CITY OF PORTLAND, MAINE

November 29, 2017

Project Name:	Boyd Street Apartments	Project ID:	2017-217, 2017-223
Address:	58 Boyd Street	CBL:	022-F-001
Applicant:	Jay Waterman		
Planner:	Matthew Grooms

RE: Staff Review Comments for 58 Boyd Street – 55-Unit Affordable Housing Development (2017-217 and 2017-225) – Planning Board Review

Figure 3: Proposed Site Plan

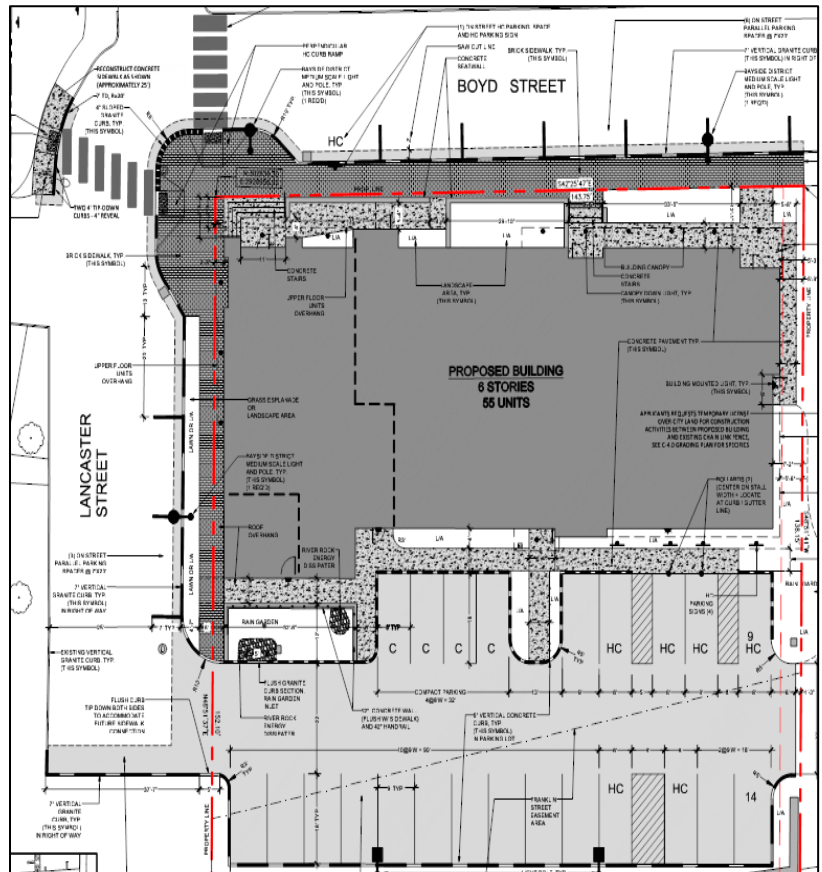
This site will be served by a new stormwater management system, composed of a rain garden feature to be located at the entrance of the proposed parking lot. This garden will provide quality treatment for the entire parking area, as well as the building roof area. Once treated, stormwater will be direct to the city's combined sewer system located beneath Lancaster Street. Overhead electrical service will be relocated underground per city standards, and the building will connect into existing water and wastewater lines located beneath Boyd Street.

Additional site improvements include significant site landscaping along the perimeter of the proposed building and within the proposed parking area, the installation of three Bayside District street lamps and a variety of canopy and building mounted light fixtures. The building will feature direct access to the Boyd Street community garden as well, located immediately south of the project site.

Figure 5: Proposed Landscaping Plan

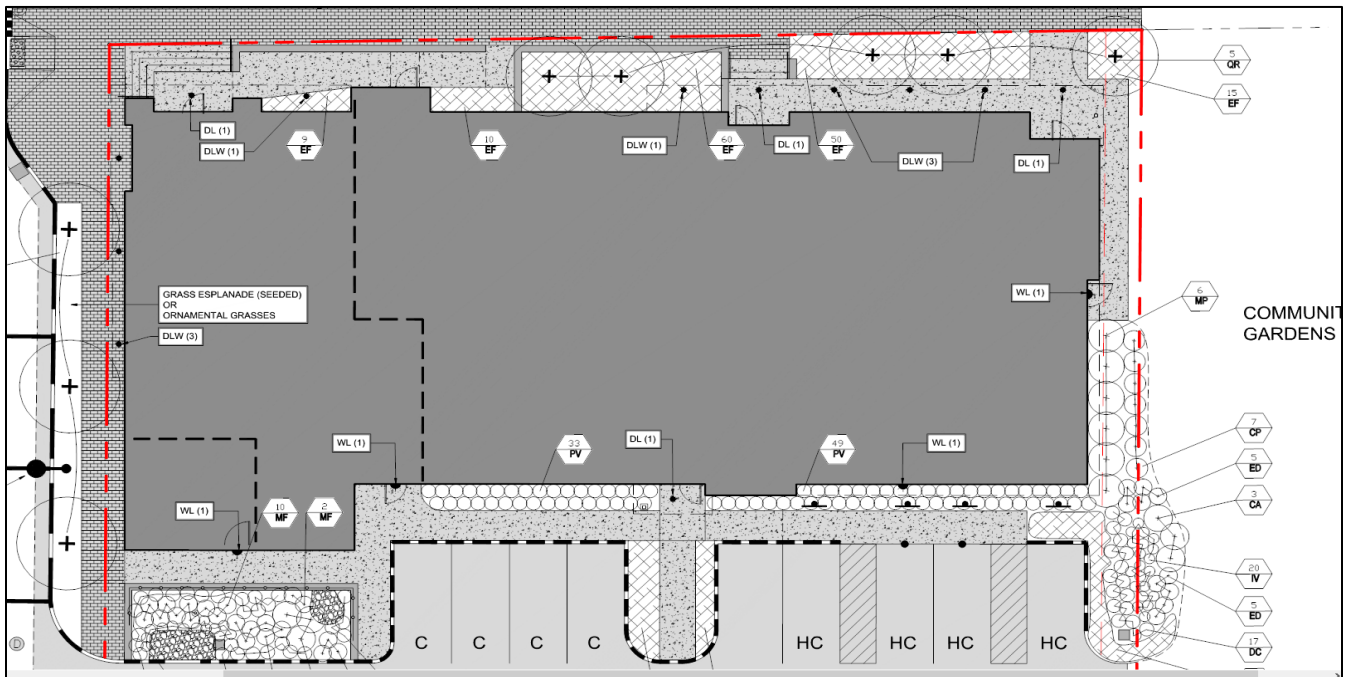
The applicant is providing twelve (12) street trees on site and will contribute a fee in lieu of the remaining forty-three (43) required street trees. The applicant is requesting that this contribution go toward landscaping improvements to the Boyd Street Urban Farm complex.

Figure 8: West and South Elevations

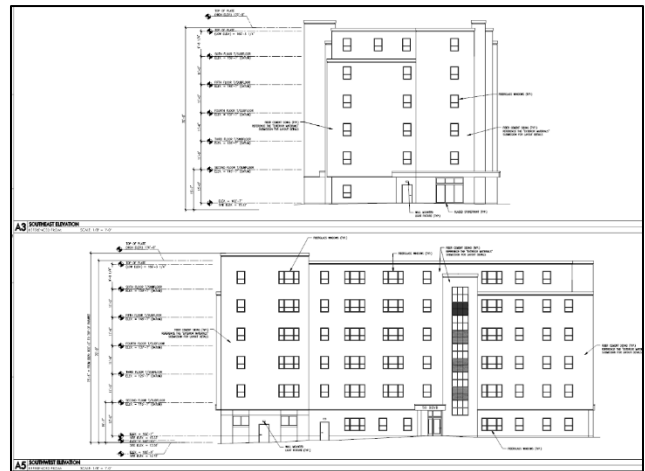
Standard e. Reinforce the public realm – appropriately scaled entries, porches, fenestration, landscaping, and architectural details – Public realm is defined with landscaped areas, high level of fenestration on ground floor, active ground floor uses with frequent entries, and canopies/overhangs. Fenestration patterns and types were revised in response to staff comment to improve the scale and proportional relationship to the pedestrian level and the overall building composition. Score lines are also proposed in the façade to add some texture, scale, and visual interest.
